CALVERT CLIFFS NUCLEAR POWER PLANT UNIT NO. 1

AMENDMENT TO FACILITY OPERATING LICENSE

Amendment No. 85
License No. DPR-53

SAFETY EVALUATION BY THE OFFICE OF NUCLEAR REACTOR REGULATION

Figure 6.2.2 Organization Chart (Two Unit Operation) - Calvert Cliffs Nuclear Power Plant
 Baltimore Gas and Electric Company

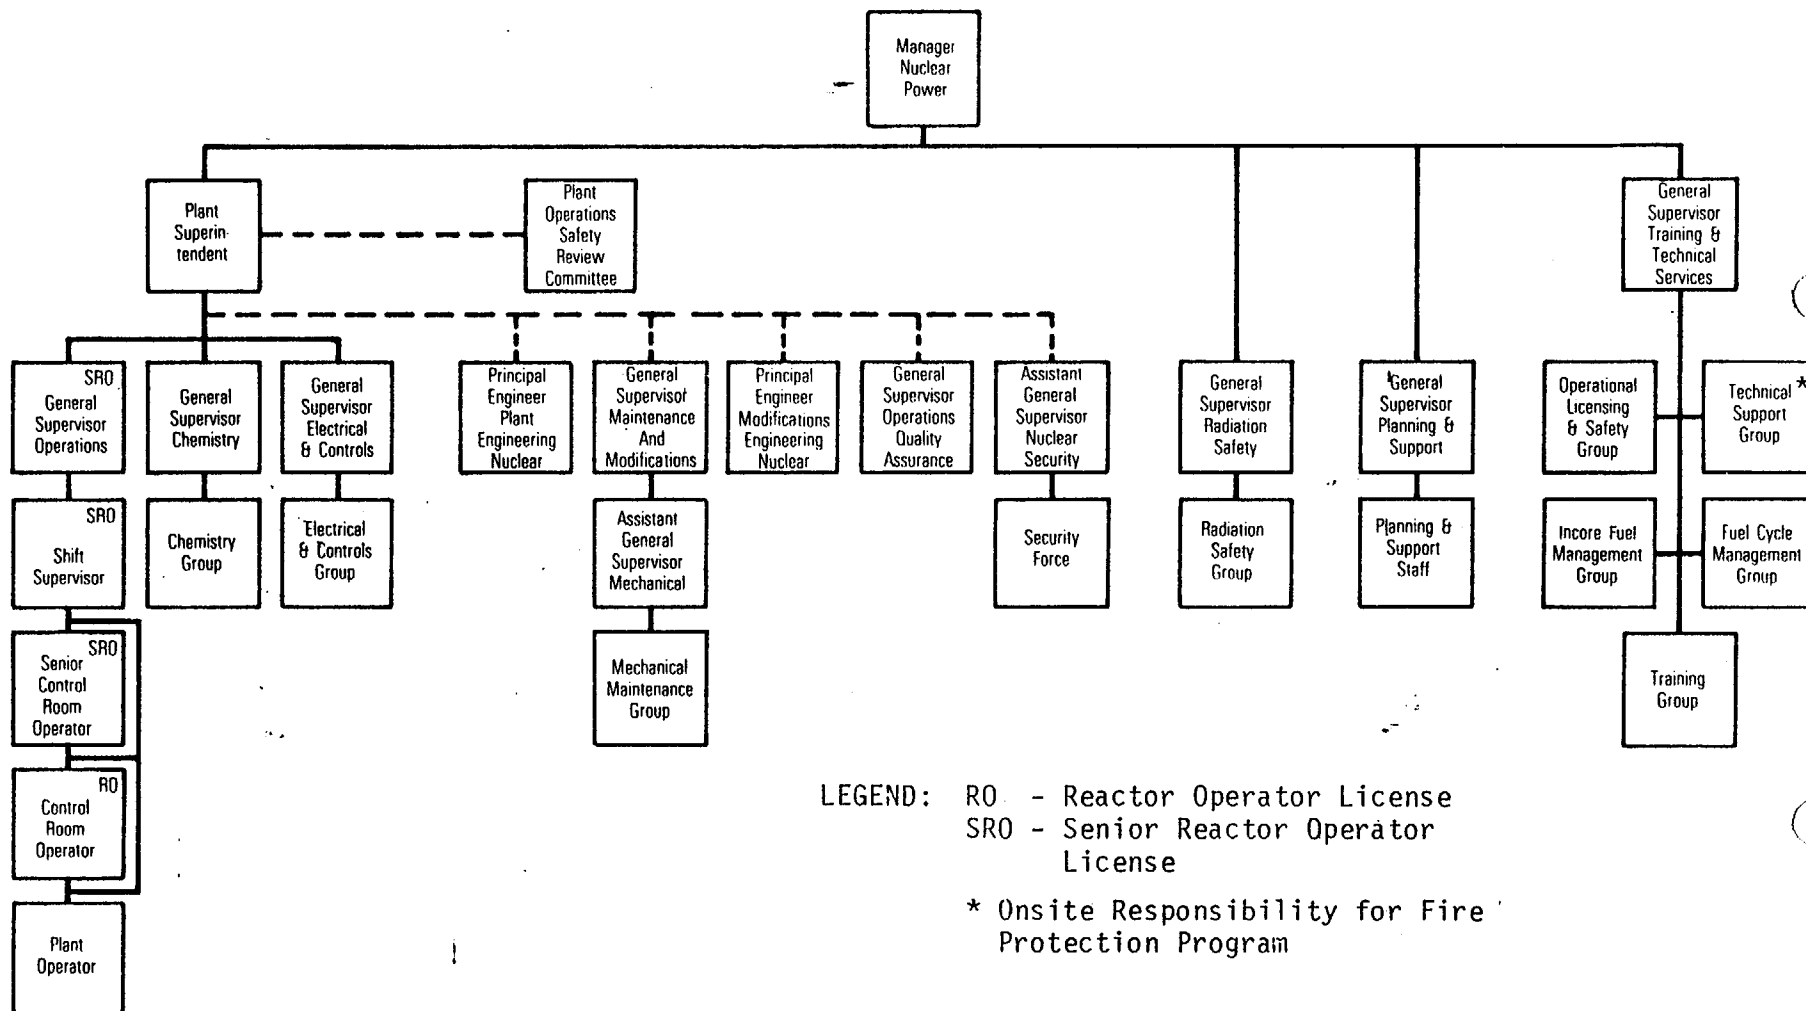
1
BG&E has proposed changes to Section 6.0 of the TS in two areas, namely Figure 6.2.2 Organization Chart - Calvert Cliffs Nuclear Power Plant, and the composition of the Plant Operations and Safety Review Committee (POSRC) membership as noted in Section 6.5.1.2. These TS changes are required to reflect changes in the on-site organization at Calvert Cliffs.

The position of Supervisor-Nuclear Fuel Management is to be eliminated at Calvert Cliffs. The Nuclear Fuel Management group will be divided into two parts, Incore Fuel Management and Fuel Cycle Management, both of which report to the General Supervisor-Training and Technical Services. A new position of General Supervisor-Planning and Support will be formed with a Planning and Support staff reporting to him, which will encompass the present responsibilities of the Supervisor-Administrative Services. The job title of General Foreman and Assistant General Foreman-Mechanical will be changed to General Supervisor-Maintenance and Modifications and Assistant General Supervisor-Mechanical, respectively. The job title of Supervisor-Calvert Cliffs Security will be changed to Assistant General Supervisor-Nuclear Security. Proposed TS Figure 6.2.2 reflects these organizational and title changes.

We have reviewed the proposed changes to the Calvert Cliffs on-site organization as reflected in TS Figure 6.2.2. We conclude that the changes will not degrade the technical or administrative functioning of this organization and are therefore acceptable. In addition, we find that the proposed change to TS 6.5.1.2 is acceptable in that the proposed change to the POSRC will not degrade the ability of the POSRC to advise the Plant Superintendent on all matters related to nuclear safety at Calvert Cliffs.
